September 28, 2017

ESC17-E034
Page No. 1

Subject: Summary of Issues Requiring Resolution: January 13, 2017
L & E Auto Sales
Naval Avenue & 2101 Burwell Place
Bremerton, Washington
VCP No.: NW2785

SITE DETAIL AND SAMPLING LOCATIONS

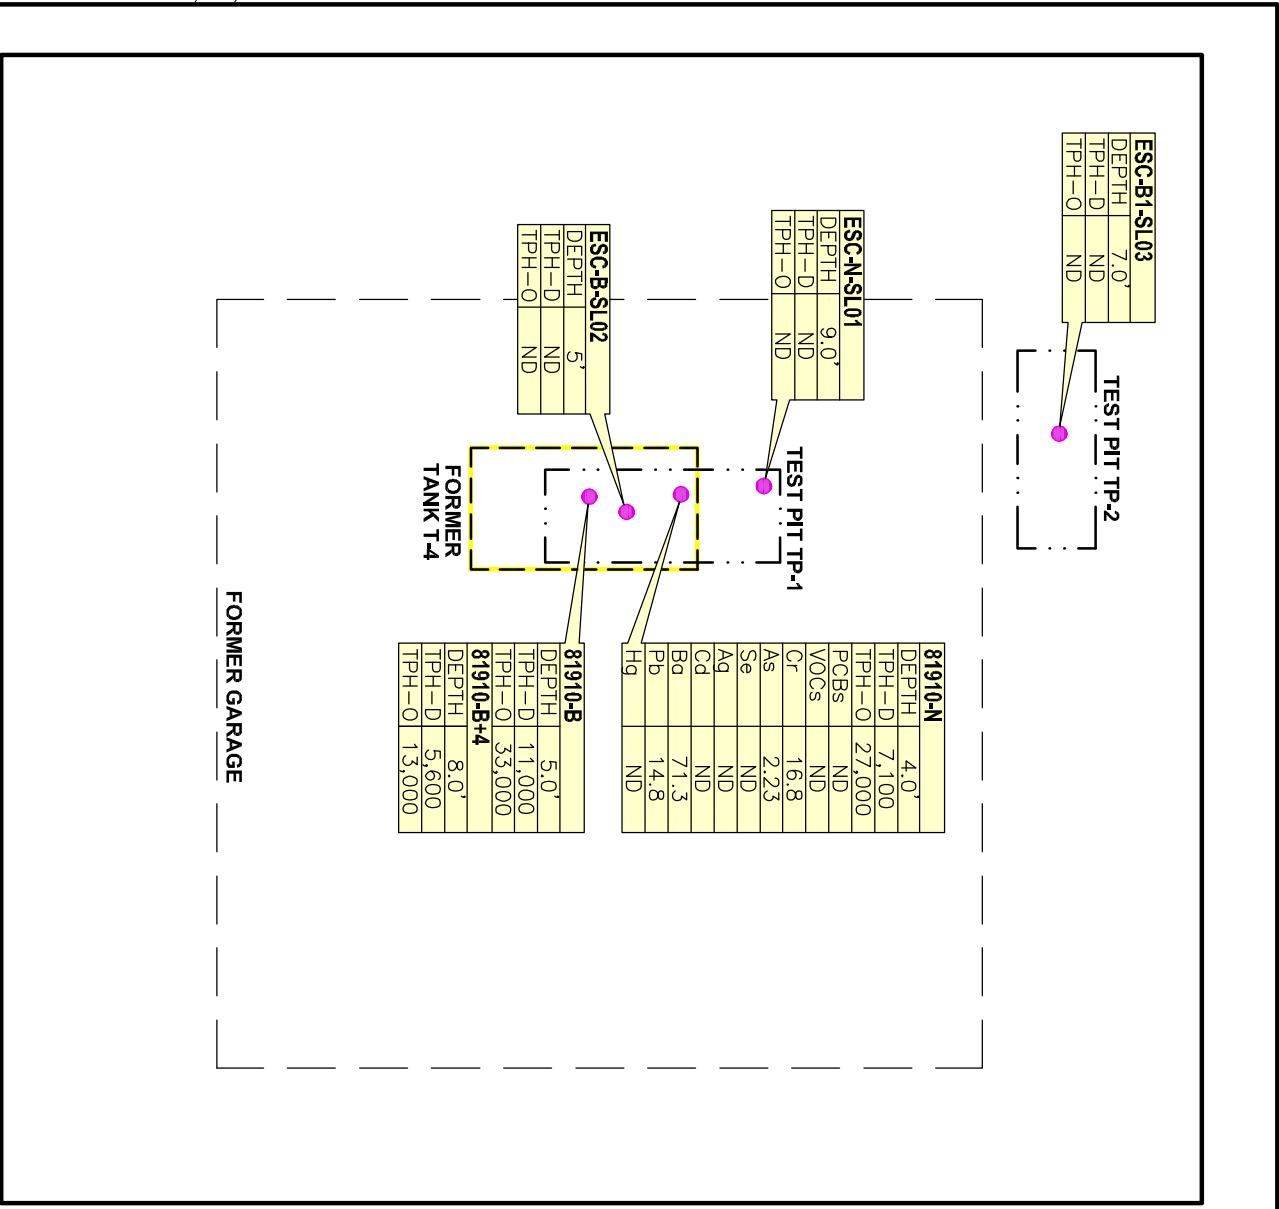
3b	<p>Horizontal and vertical extent of soil contamination not delineated; former waste oil UST. DLH soil sample 81910-B+4 (8 ft depth) had TPH-D and TPH-O greater than cleanup levels and is outside the bounds of test pit 1, leaving the extent of impacts from the former waste oil tank as unresolved; also see bullet 6 below.</p>	<p>We disagree that confirmation soil samples from beneath shallower samples showing contamination were not collected. Sample ESC-E002-N-SL01 was collected below these two 81910 samples. Figures have been simplified and expanded to better illustrate conditions at the Site. Revised figures are provided with this letter.</p> <p>Associated confirmation samples between DLH samples and bounding EnviroSound samples are presented for the waste oil tank and the gasoline tanks in corrected Tables 1 and 2 of this letter.</p>

The source of contamination (waste oil tank and the hydraulic lift) has been removed along with the petroleum-impacted soils. No stained soils were observed in the EnviroSound test pit excavated in the former waste oil tank location. Diesel and lube oil were not detected in soil samples collected by EnviroSound at 5 and 9 feet bgs below the areas of concern.

EnviroSound test pit TP-2 excavated in the area of DLH boring B-1 did not encounter any petroleum stained soils and diesel was not detected in the sample collected at 7.0 feet bgs.

FUEL TANK EXCAVATION, SAMPLING, AND RESULTS

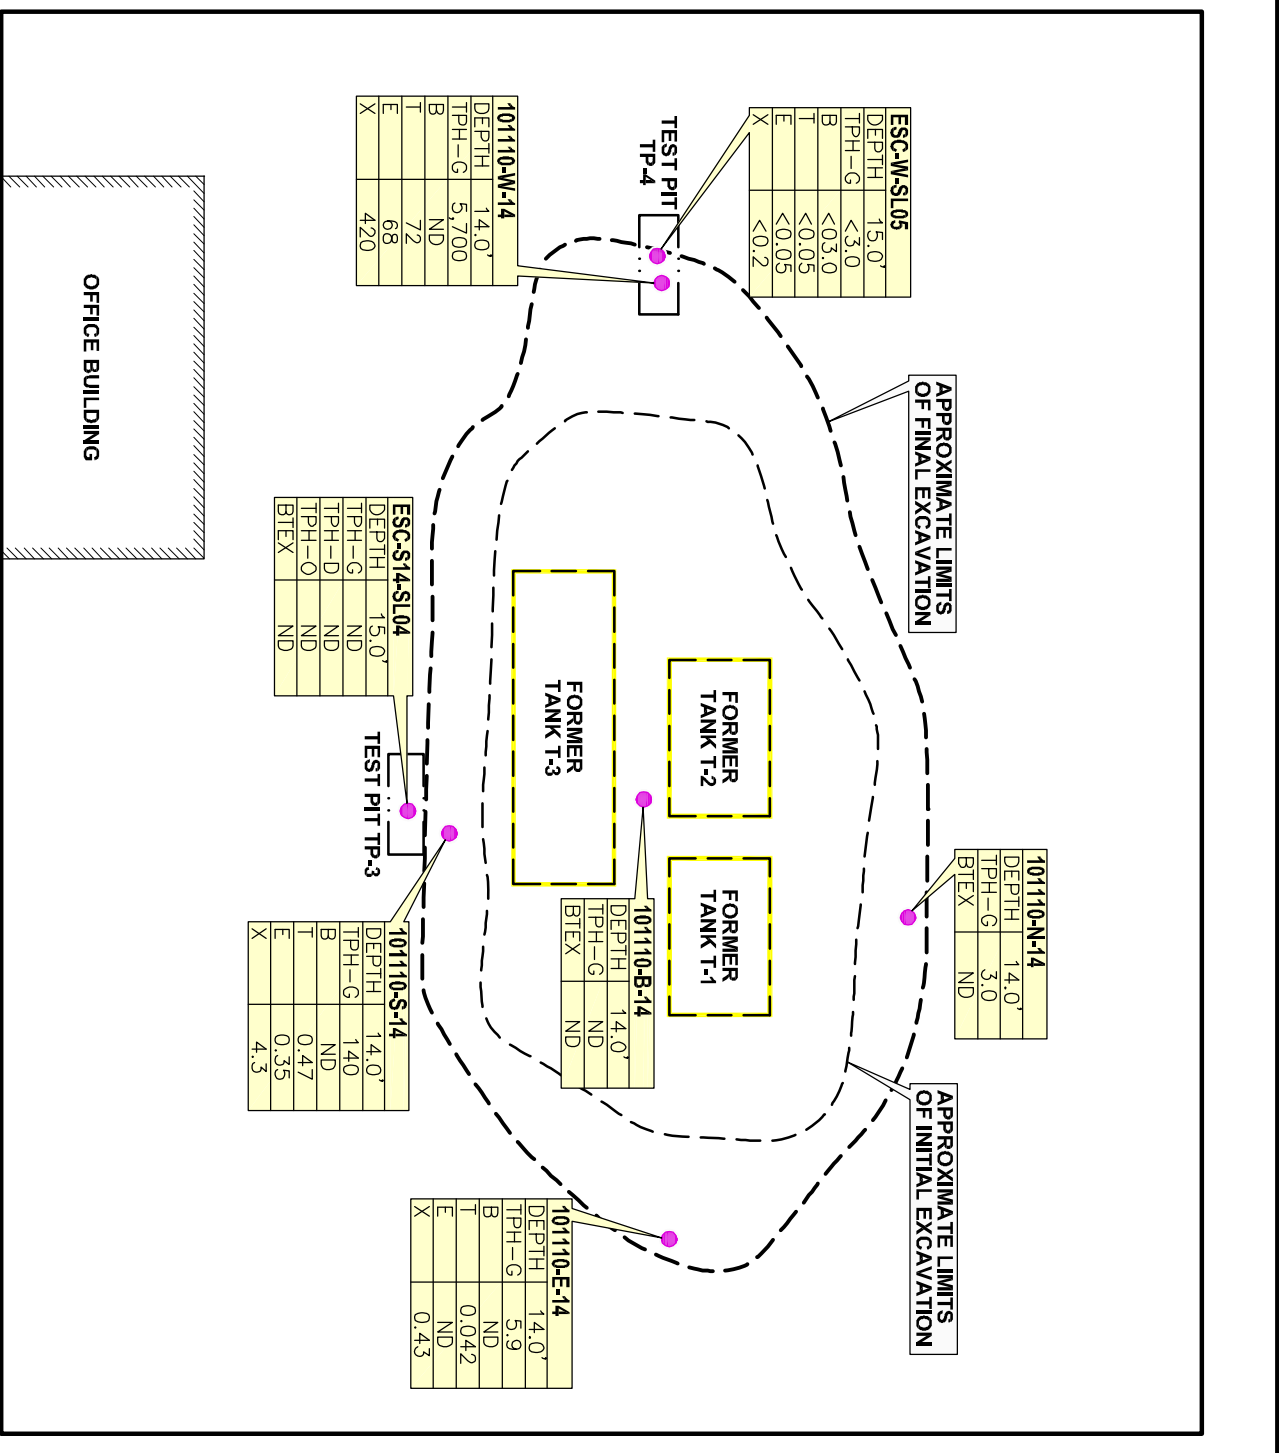
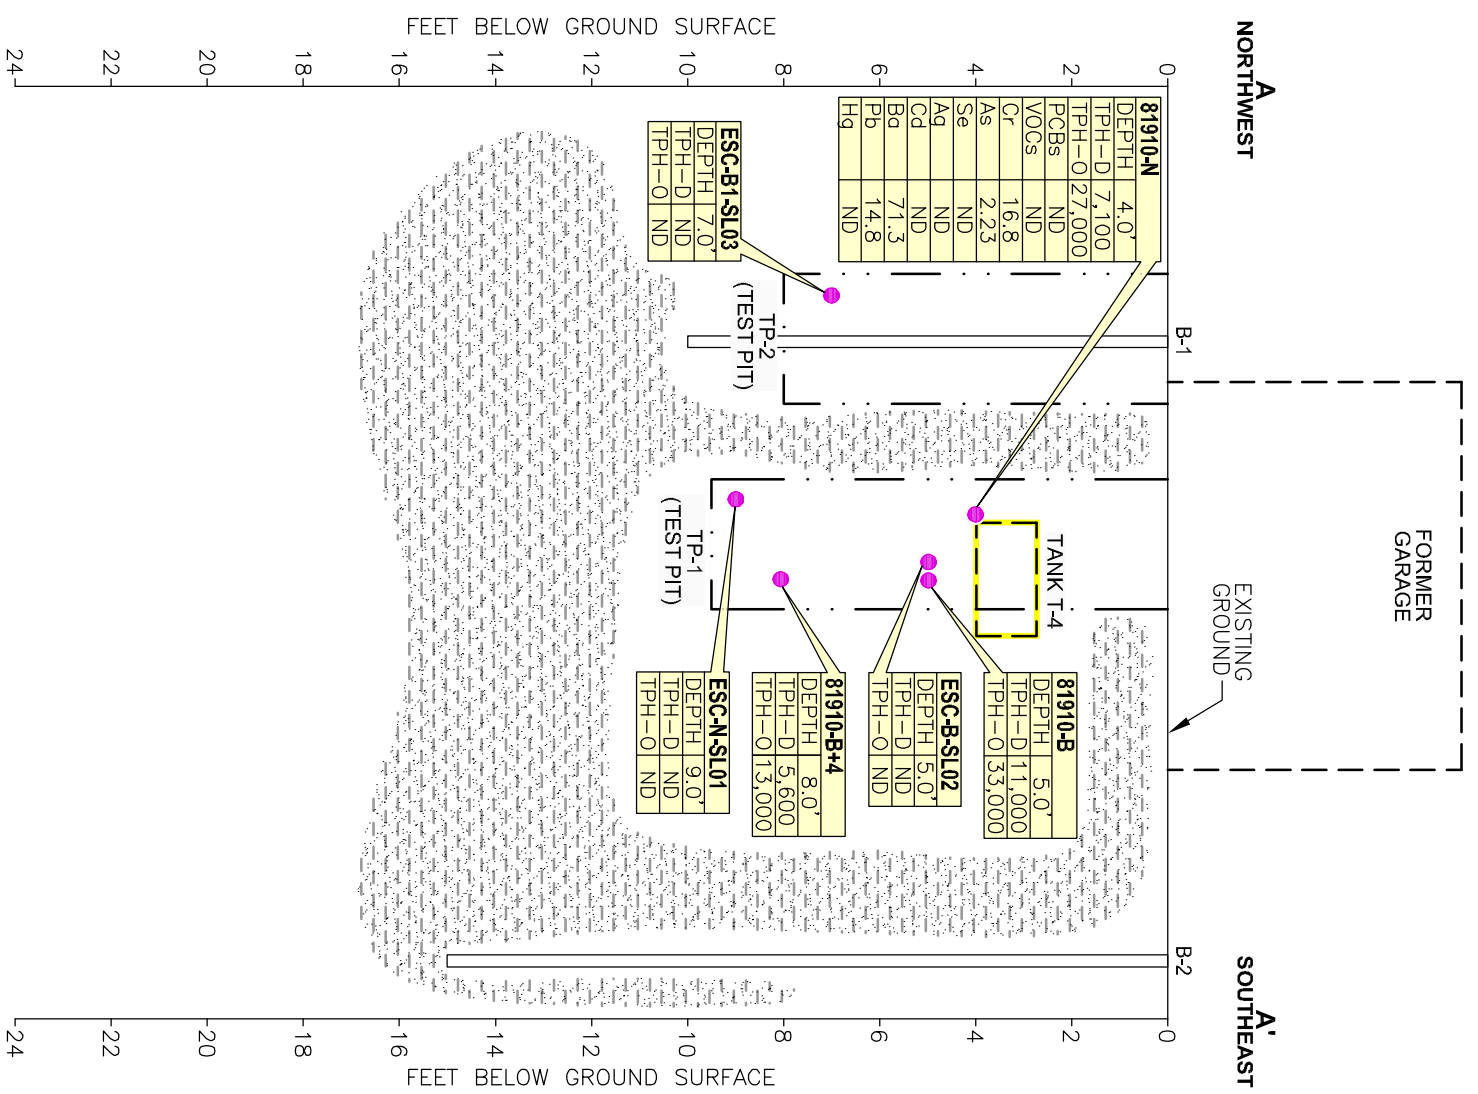
Bullet	Data Gap/Issues to be Resolved	Response
2	<p>Complete description of Site geology and hydrogeology, including boring logs and local well logs, and locations of subsurface utilities. Request for additional information provided by ESC and DLH boring logs. Use this information to develop a description of the hydrogeologic framework and CSM, per the RI report checklist; include a scaled hydrogeologic cross section showing former USTs, remedial excavations and soil sampling results. All maps and cross sections must be to scale.</p>	<p>Cross sections and revised maps are included as attachments to this letter.</p>
3a	<p>Horizontal and vertical extent of soil contamination not delineated; former gasoline USTs. Confirmation soil samples from the final UST excavation depth of 14 feet were not collected directly beneath the locations where shallower samples showed TPH-G ranging from 4,900 to 12,000 mg/kg.</p>	<p>We disagree that confirmation soil samples from beneath shallower samples showing contamination were not collected and we regret this was not clearer in our previous reports. The primary purpose of installation of the test pits and sample collection was to identify potentially stained soil and find vertical and horizontal boundaries of potentially remaining soil contamination. Tables and figures have been simplified and expanded to better show locations and depths of samples. Please see revised figures Attachment 1.</p>

The source of contamination (three gasoline USTs) has been removed, as has 75.95 tons of impacted soil. EnviroSound collected samples below samples previously collected by DLH to determine the vertical extent of contamination with corresponding sample results shown on Table 1. Samples collected from borings placed around the USTs during the Phase II ESA by DLH had no detectable concentrations of NWTPH-Dx at depths ranging from 15 to 20 feet and no petroleum-impacted soils were observed in test pits logged by EnviroSound adjacent to the UST excavation.
